Engineering has reviewed the plans for the Woodlands Landing at Echo Farms-Tract 3A project submitted February 1, 2019 and have the following comments:

WOODLANDS LANDING AT ECHO FARMS - TRACT 3A

DESIGN DOCUMENTS

SANITARY SEWER RUN B - PROFILE VIEW
 HORIZONTAL SCALE: 1"=50'
 VERTICAL SCALE: 1"=5'

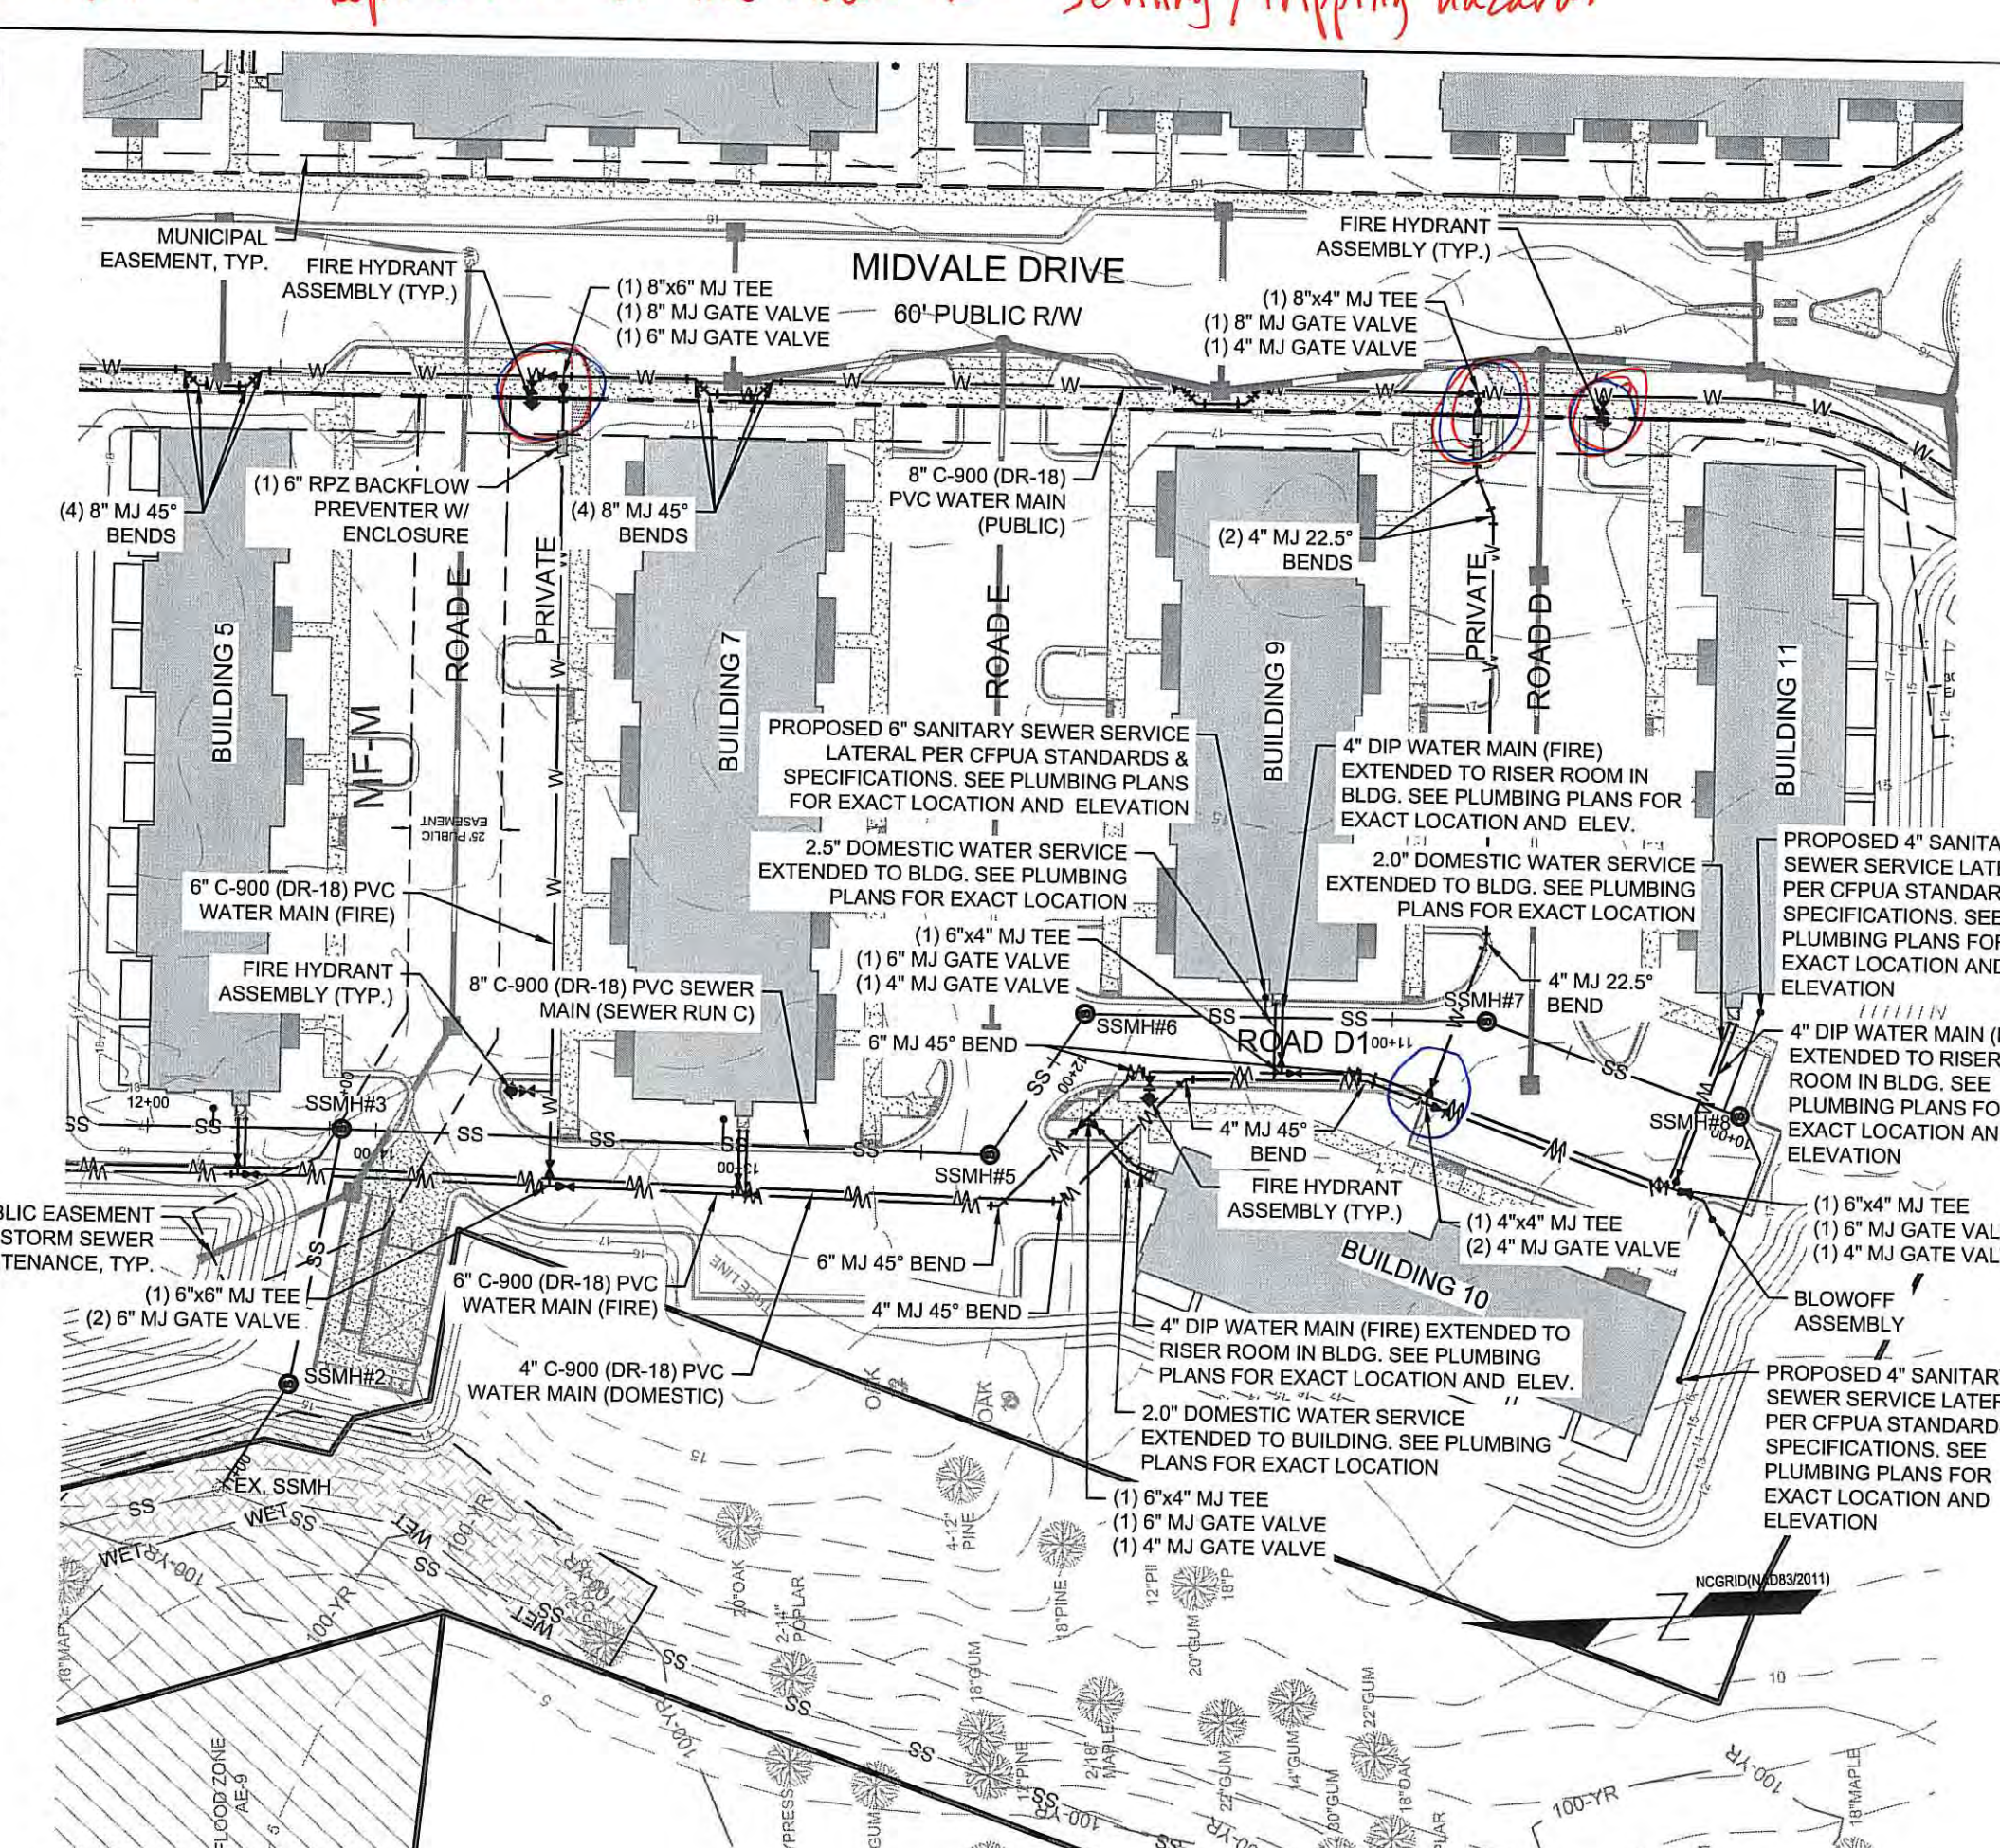
Valves, Fti's, cleanouts, etc. need to be kept outside of the sidewalk - setting/tripping hazard.

MIDVALE DRIVE - TYPICAL CROSS SECTION
NOT TO SCALE

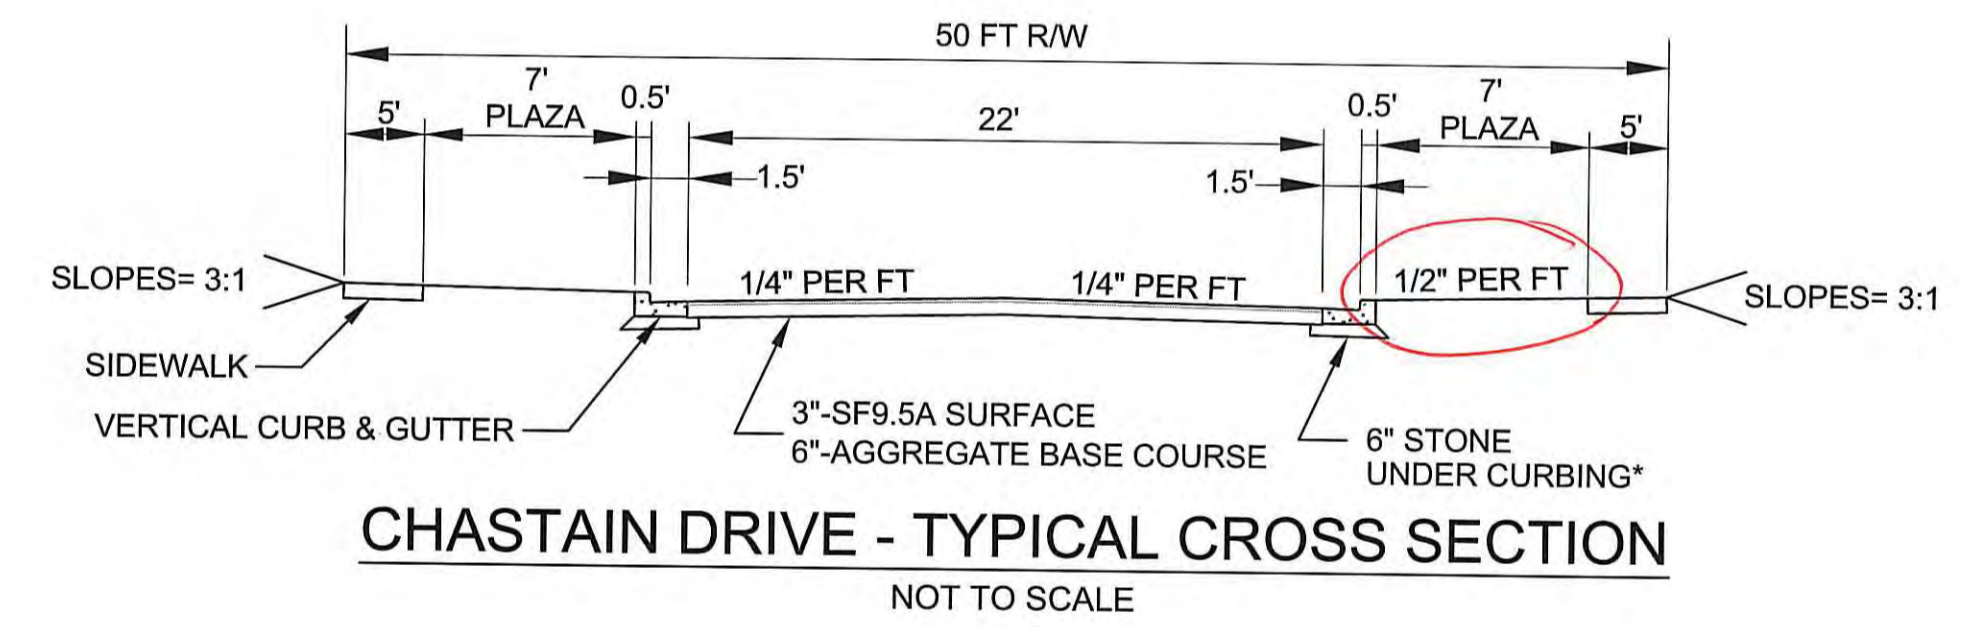
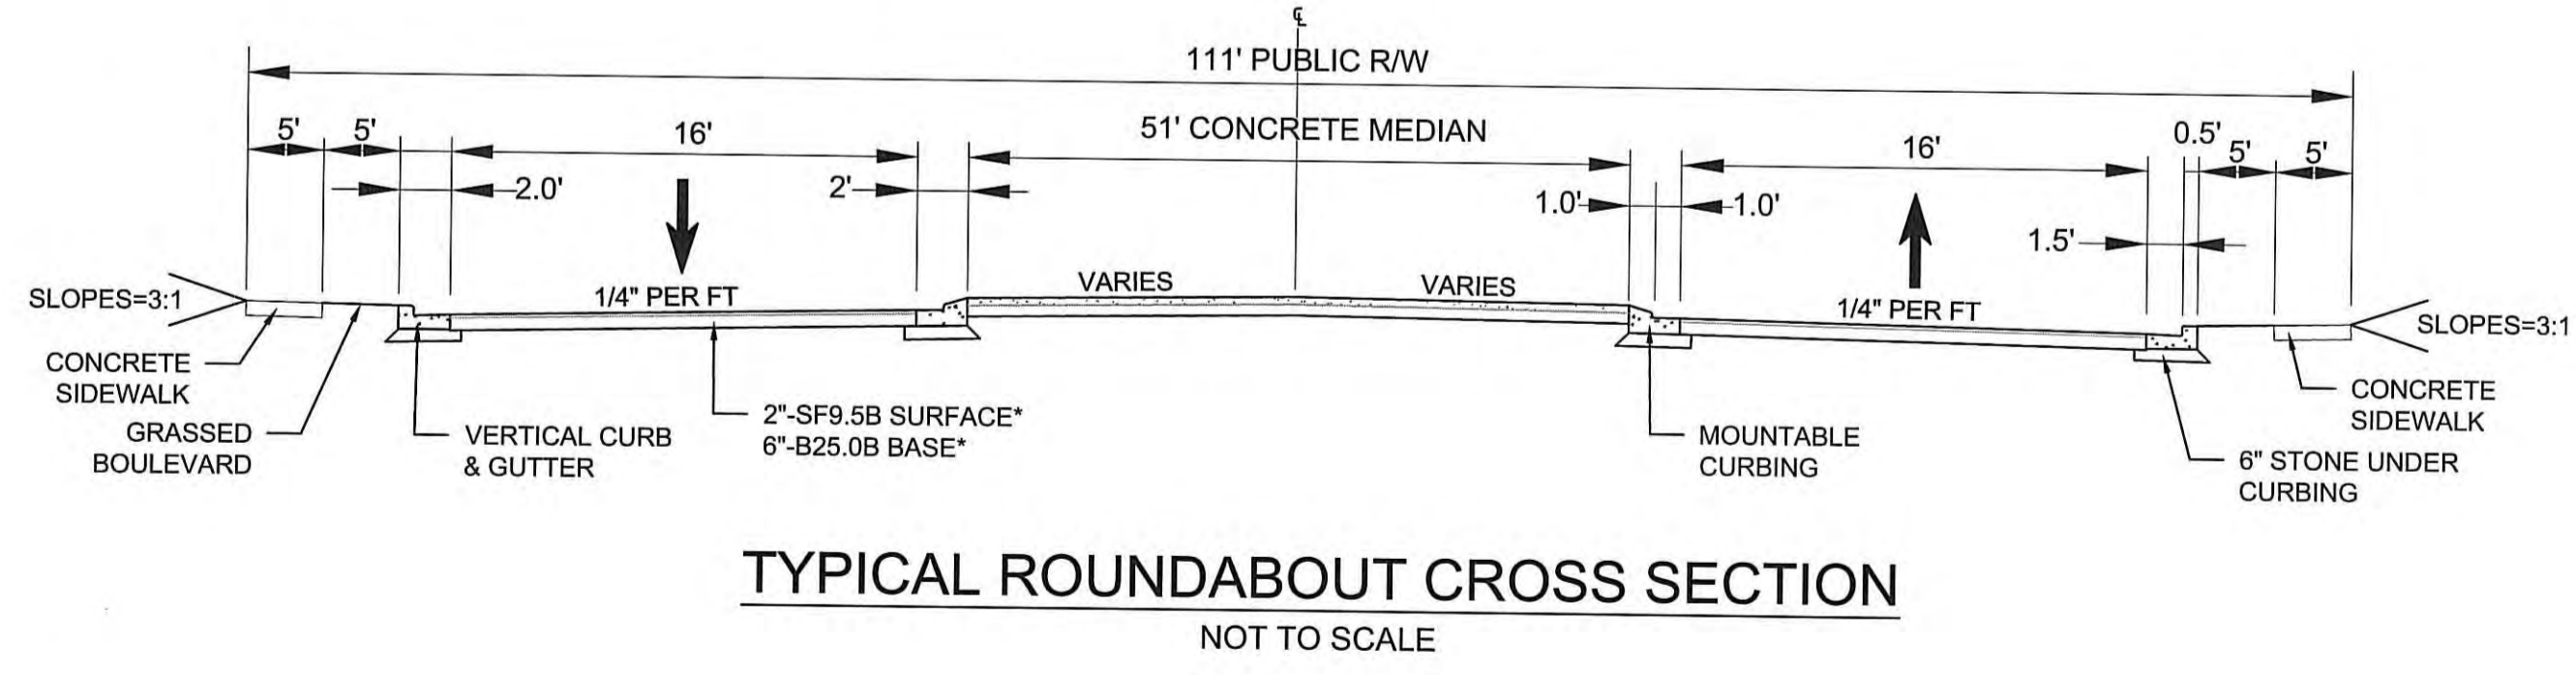
Cross slopes for plaza/sidewalk are to 1.5% (1% min / 2% max.) per the technical standards.
